Subject: ADDENDUM NO. 2
ARTIFICIAL TURF PROJECT-
POPLARVILLE SCHOOL DISTRICT
Poplarville, Mississippi

Attached is Addendum No. 2 for the above referenced project.

DRAWING NUMBER: 13

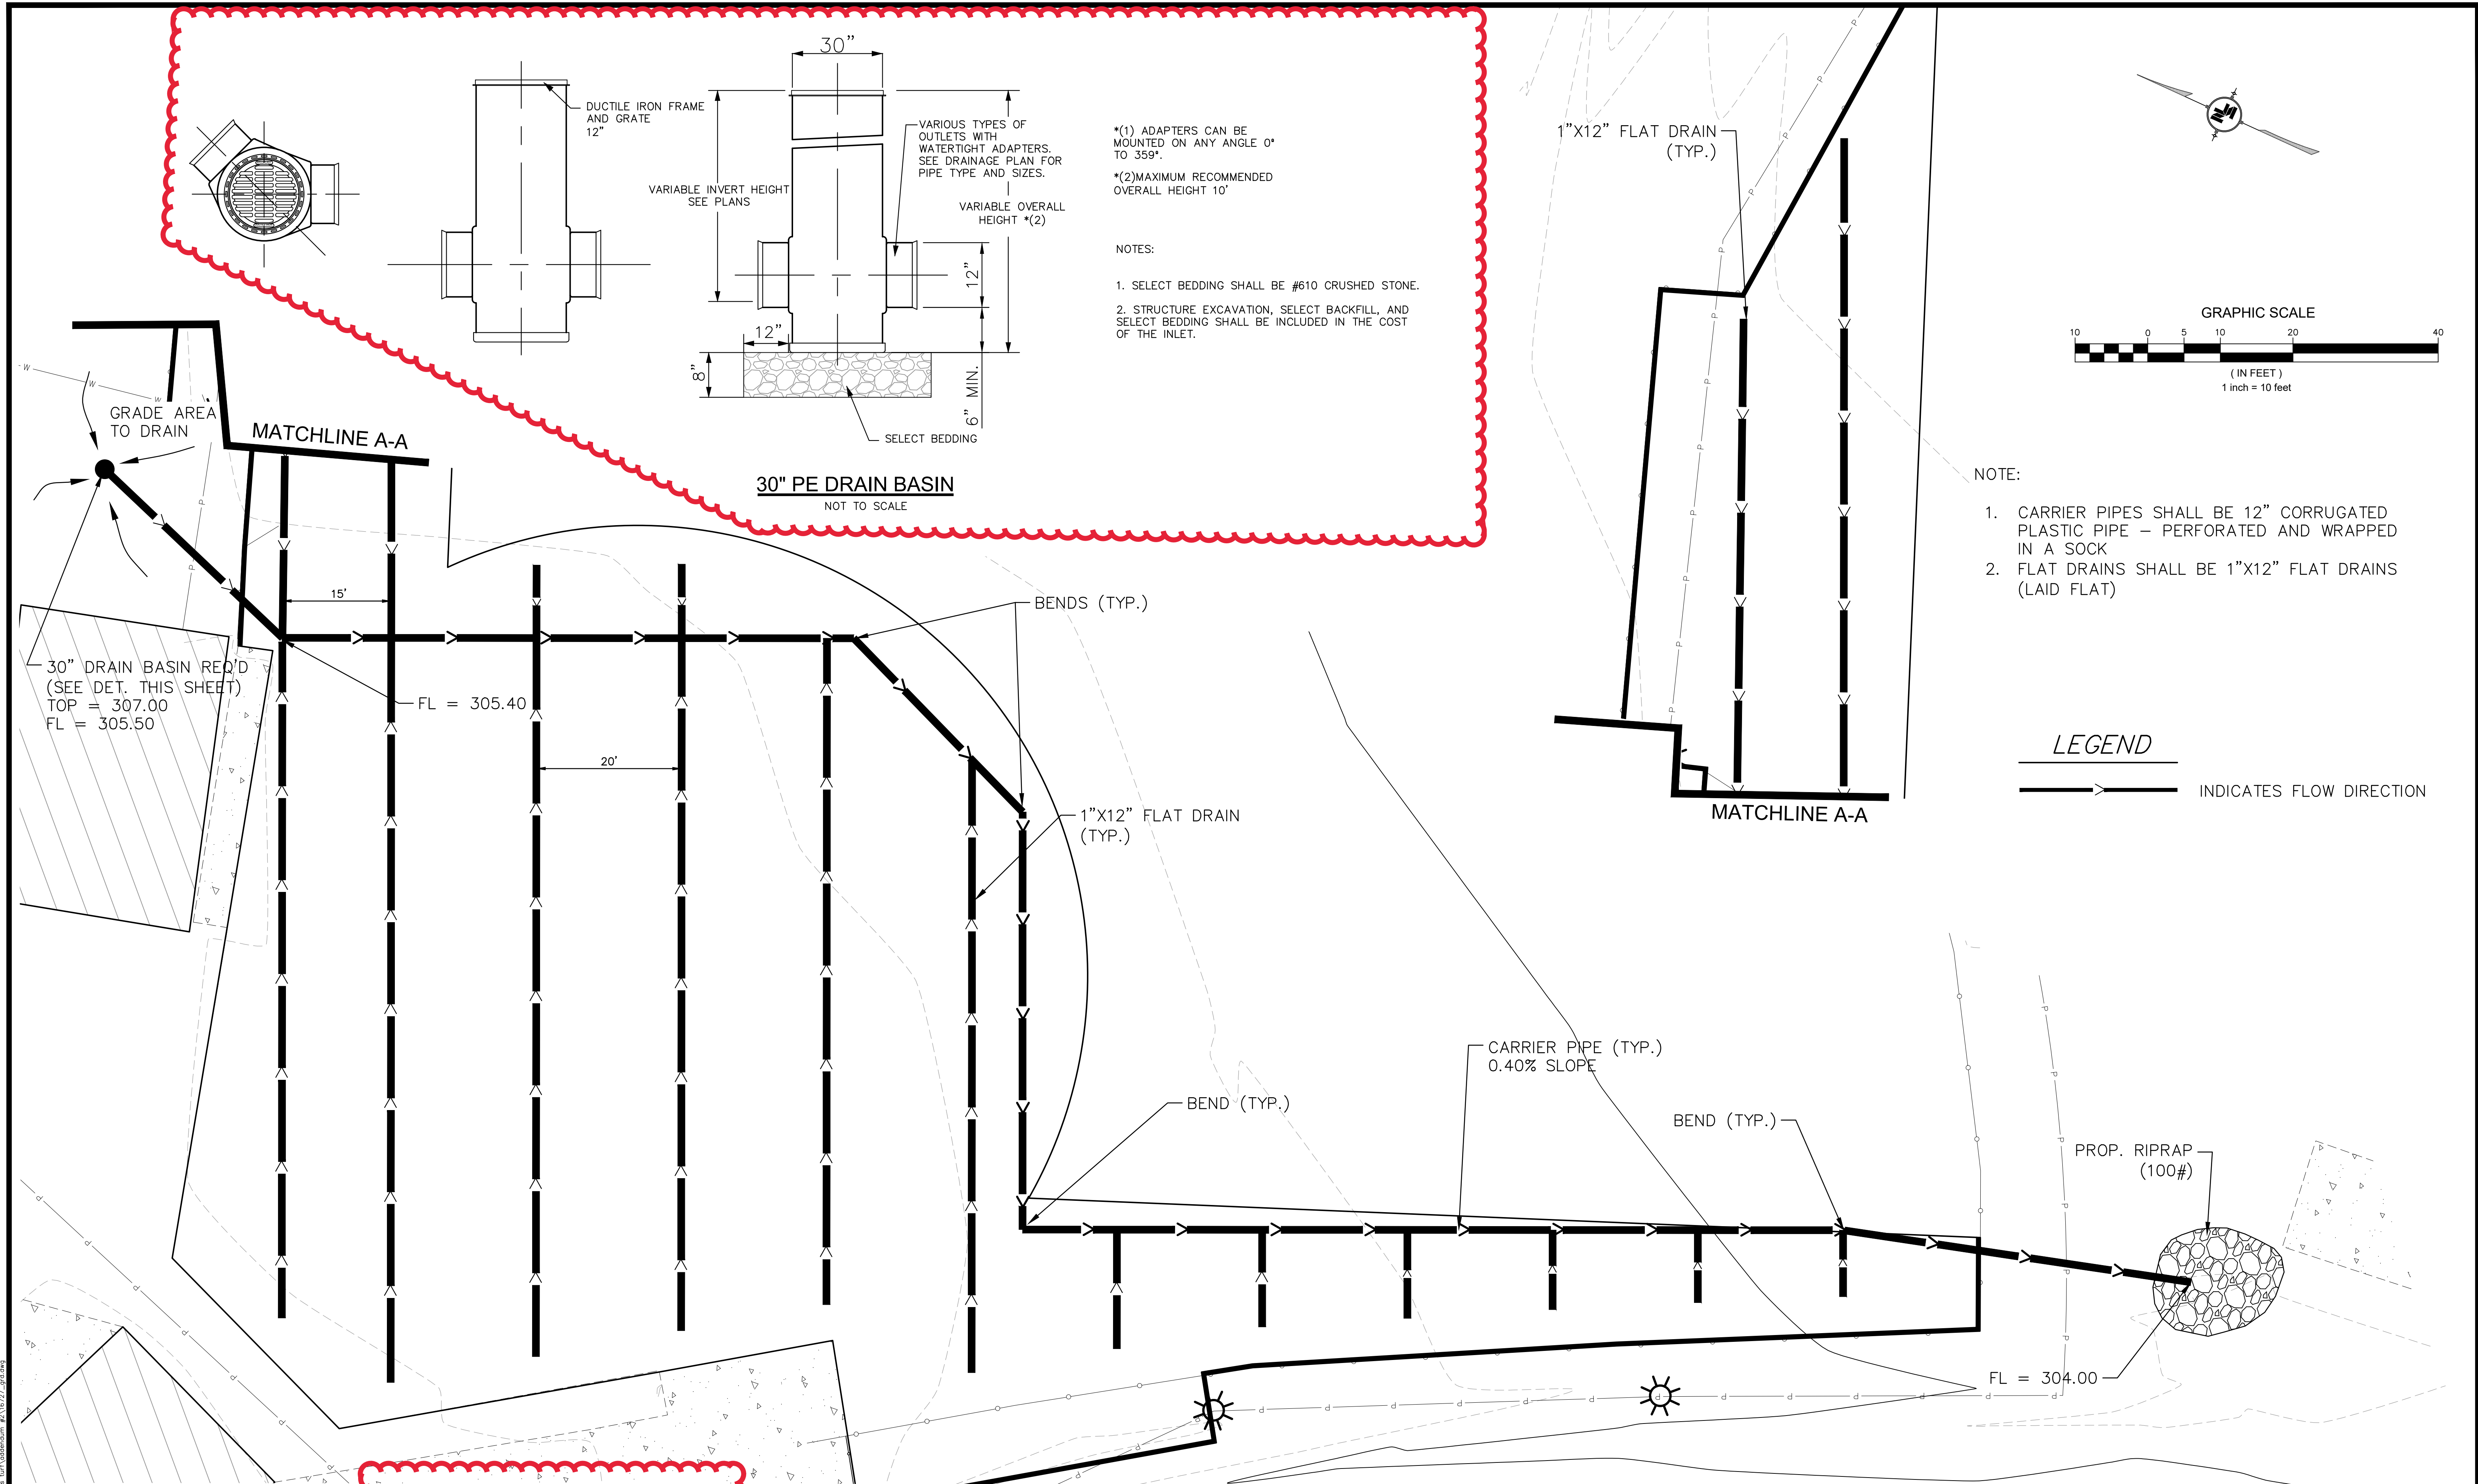
4. Replace DRAWING 13 (WKG-3 / DRAINAGE PLAN SOFTBALL) with attached **DRAWING 13 (WKG-3 / DRAINAGE PLAN SOFTBALL).** (1 PAGE). **Note addition of detail.**

NOTICE TO DRAWING HOLDER NEEL—SCHAFER, INC., HEREINAFTER REFERRED TO AS THE ENGINEER HAS PREPARED AND FURNISHED THIS DRAWING TO THE OWNER FOR USE ON THIS PROJECT ONLY. THIS DRAWING SHOULD NOT BE USED ON EXTENSIONS OF THIS PROJECT OR ON ANY OTHER PROJECT. ANY REUSE OF THIS DRAWING, WITHOUT WRITTEN VERIFICATION OR ADAPTATION BY THE ENGINEER, SHALL BE AT THE REUSER'S SOLE RISK AND THE REUSER SHALL INDEMNIFY AND HOLD HARMLESS THE ENGINEER FROM ALL CLAIMS, DAMAGES, LOSSES AND EXPENSES, INCLUDING ATTORNEY'S FEES ARISING OUT OF OR RESULTING THEREFROM.				REVISIONS				DRAWING INFORMATION				<div>ARTIFICIAL TURF PROJECT</div> <div>POPLARVILLE SCHOOL DISTRICT POPLARVILLE, MS</div>				<div>NEEL-SCHAFER <i>Solutions you can build upon</i></div>				DRAINAGE PLAN SOFTBALL			
NO.	DATE	BY	DESCRIPTION	I-S PROJECT NO.: 16727.000																			
1	2-7-2022	DAL	DETAIL ADDED PER ADDENDUM NO. 2	FILENAME: 16727_GRD.DWG
